CONTRACT ID NO. 161245

ADDENDUM # 2

Subject: Jefferson County, NHPP IM 2653 (039)

(1) Revised - Plans - R2, R2B, R2E, R2F, R7, R9, T001

ITEM NO. SHEET NO. COUNTY OF JEFFERSON 5-474.00 T001

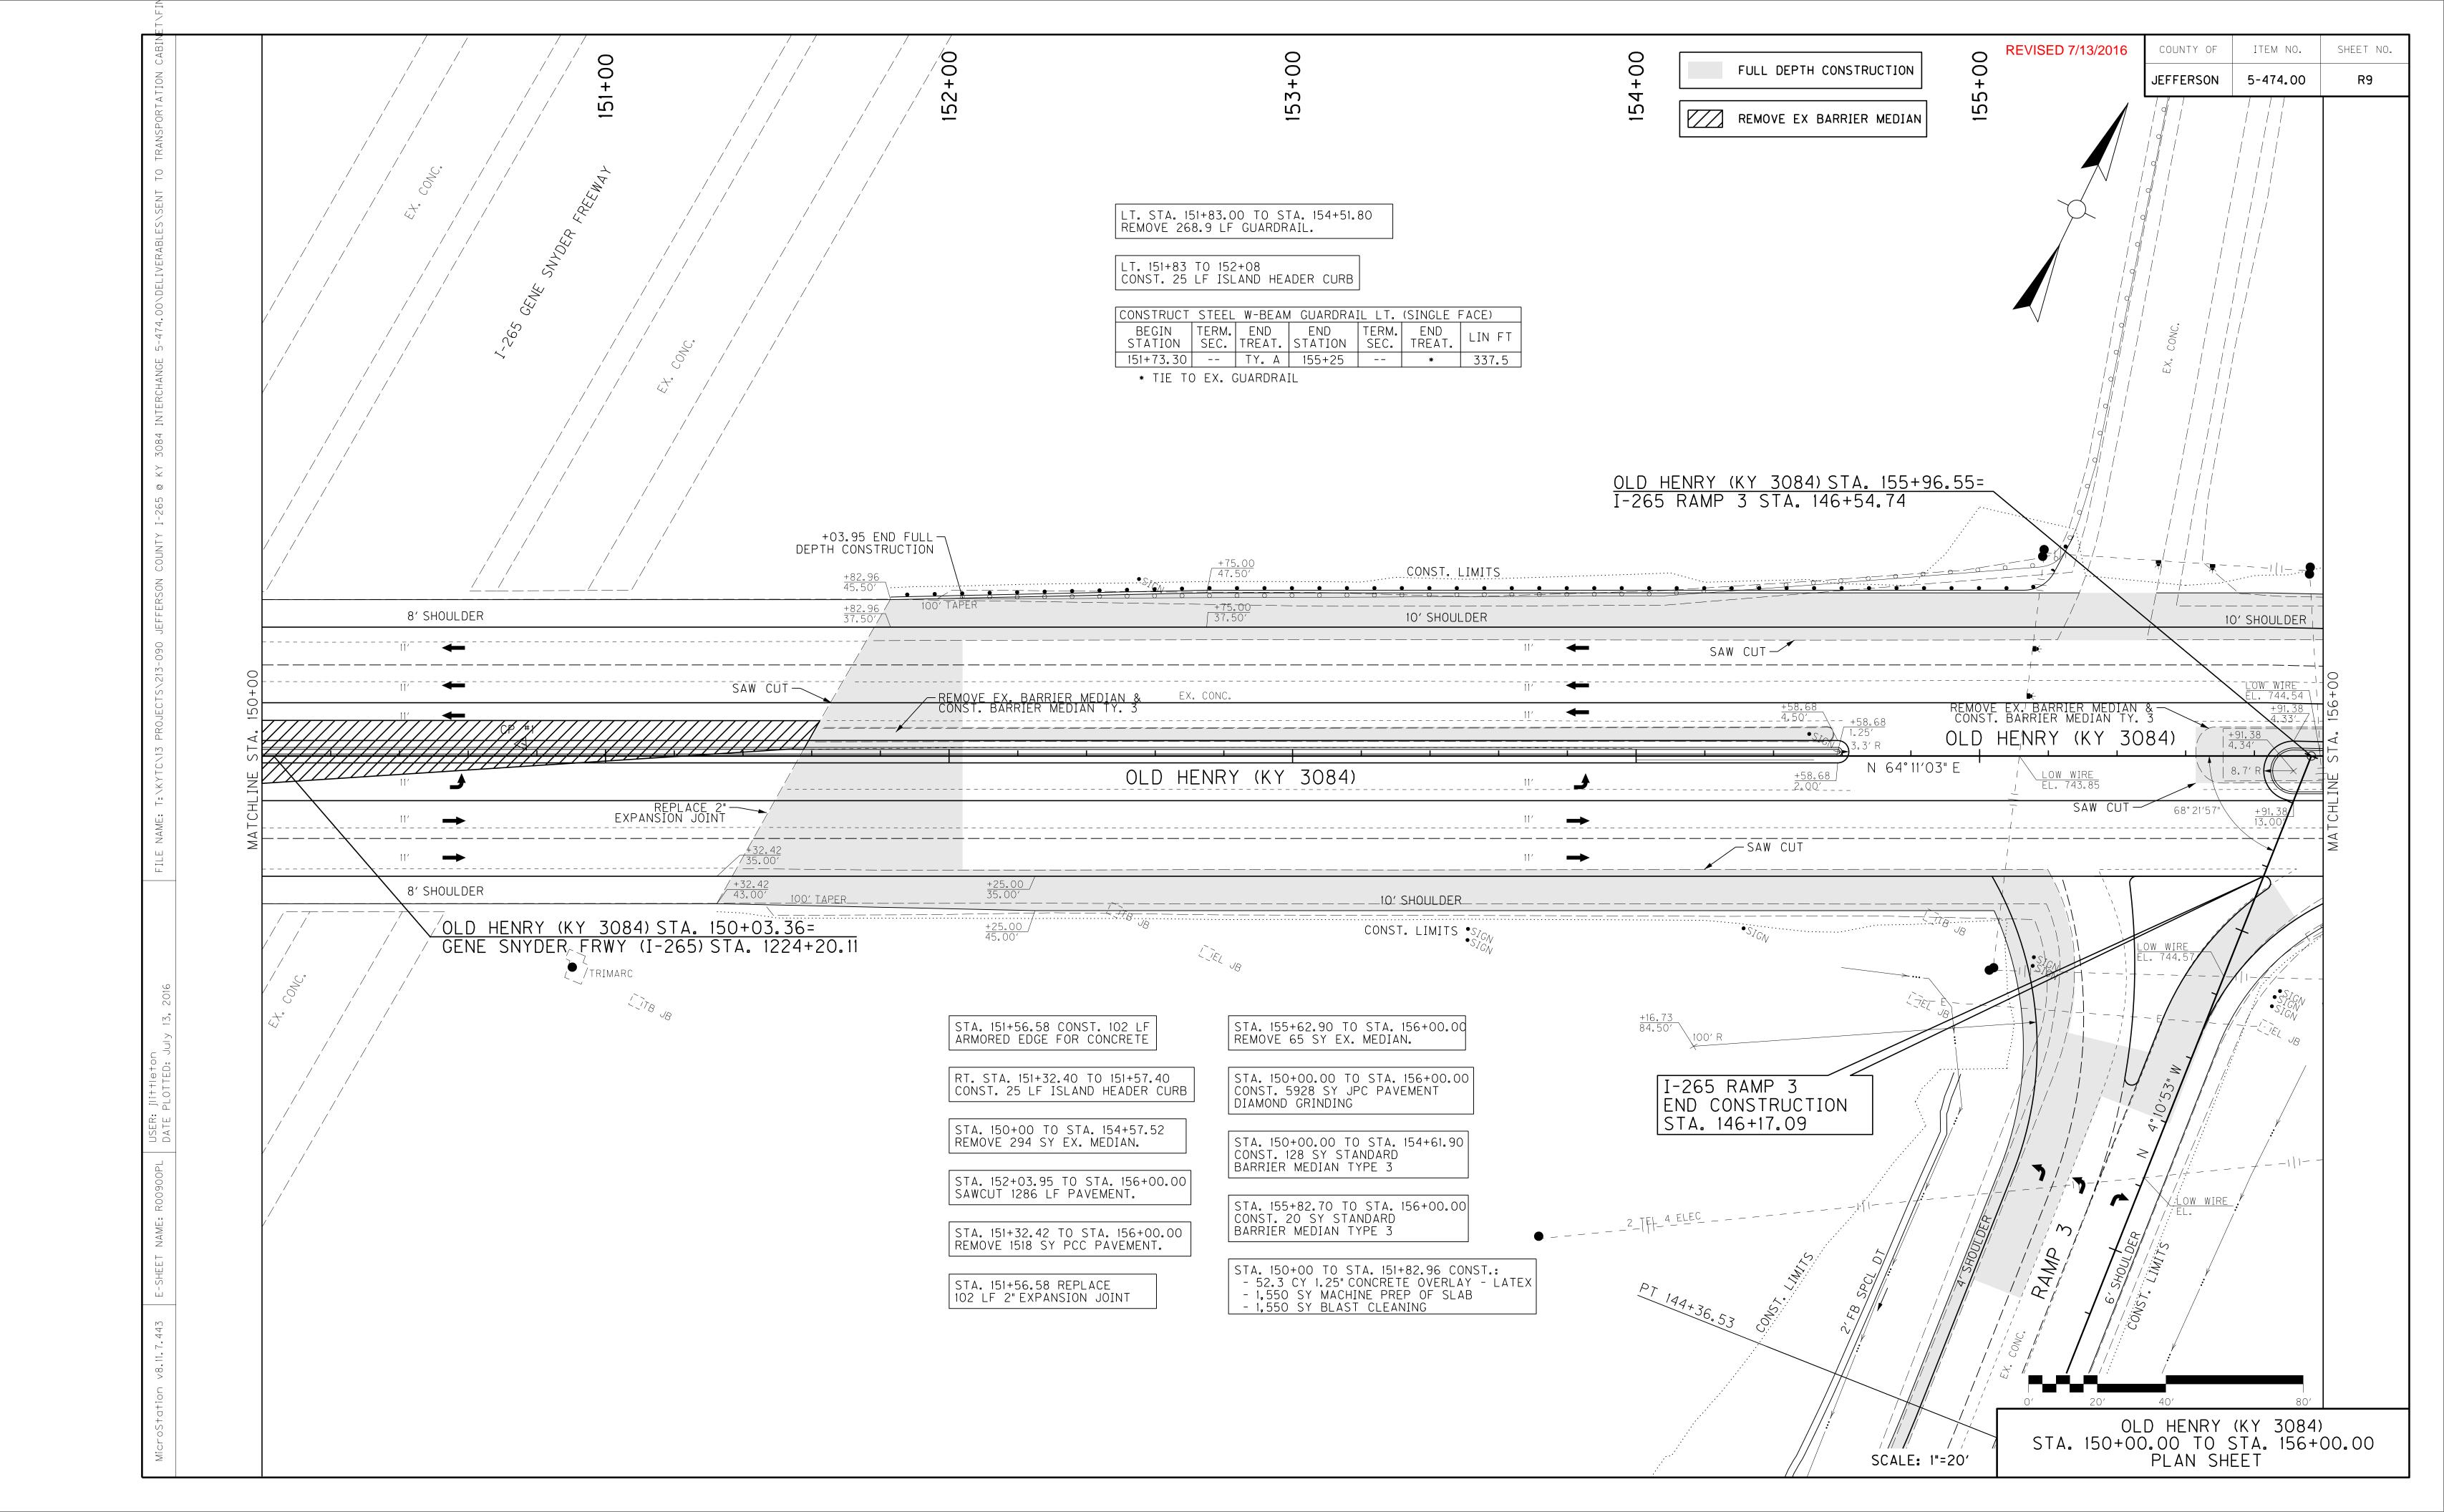
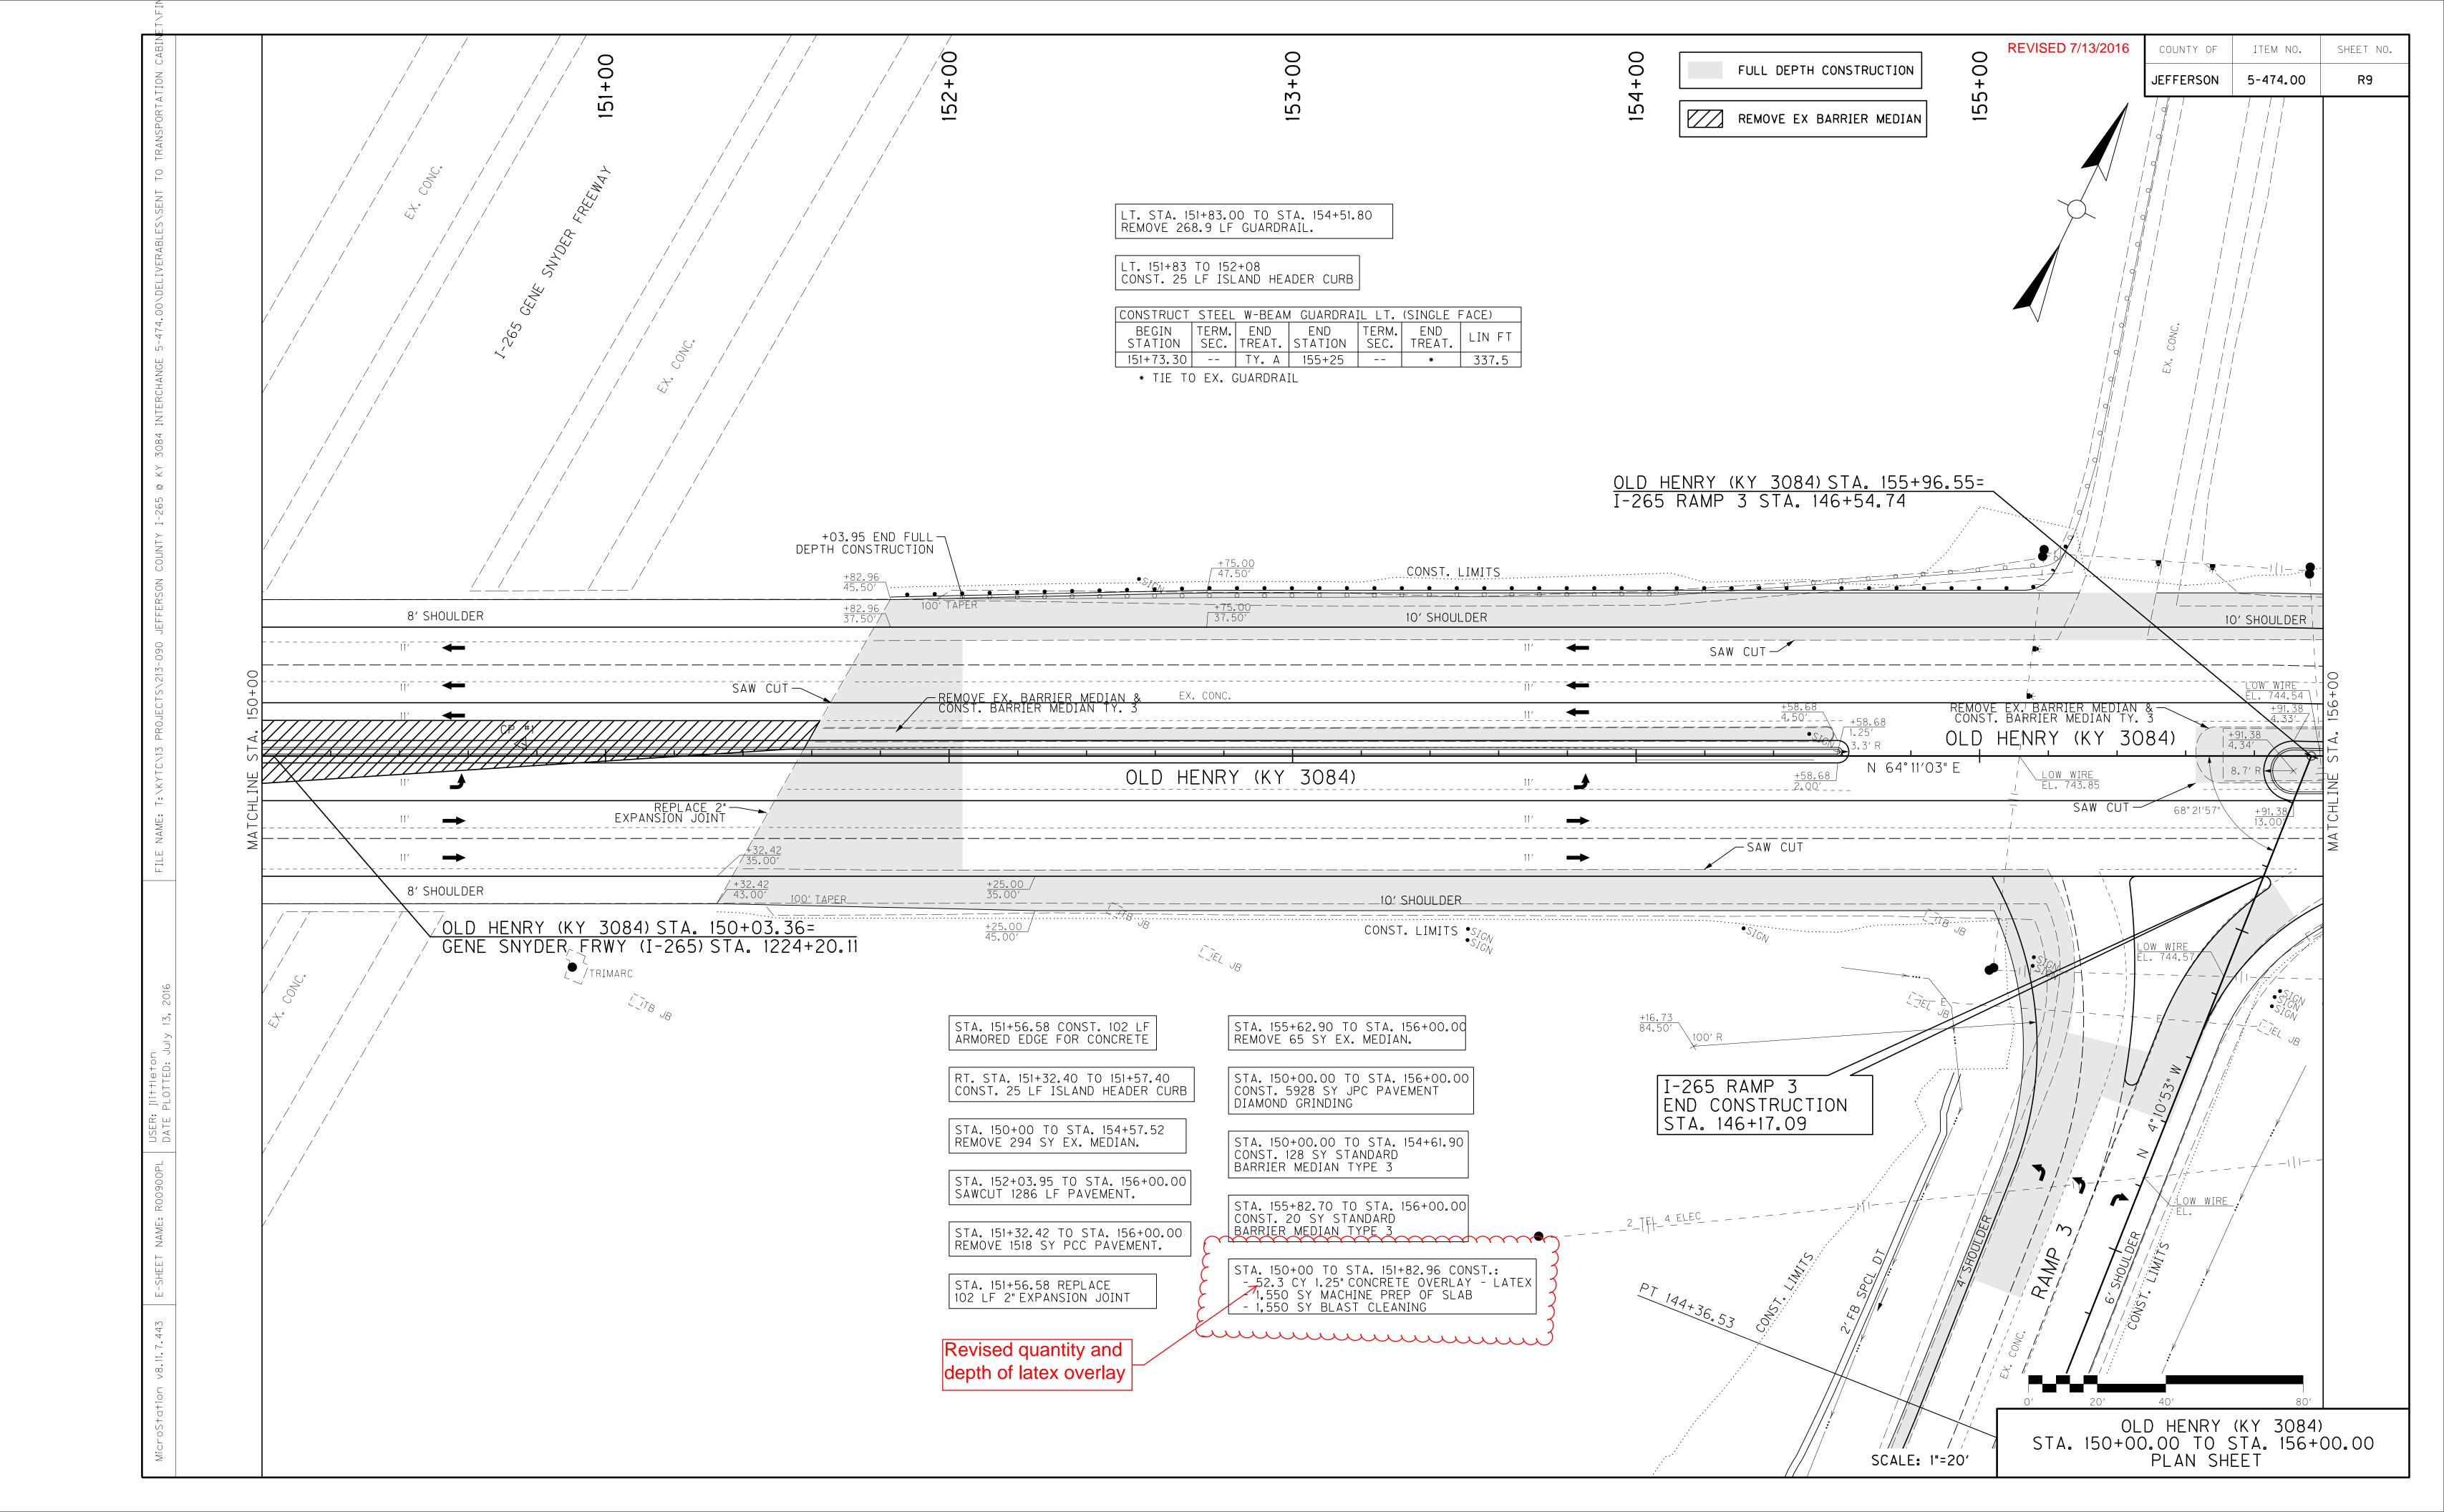
DELETED BID ITEM AND QUANTITY FOR SIGNAL CONTROLLER
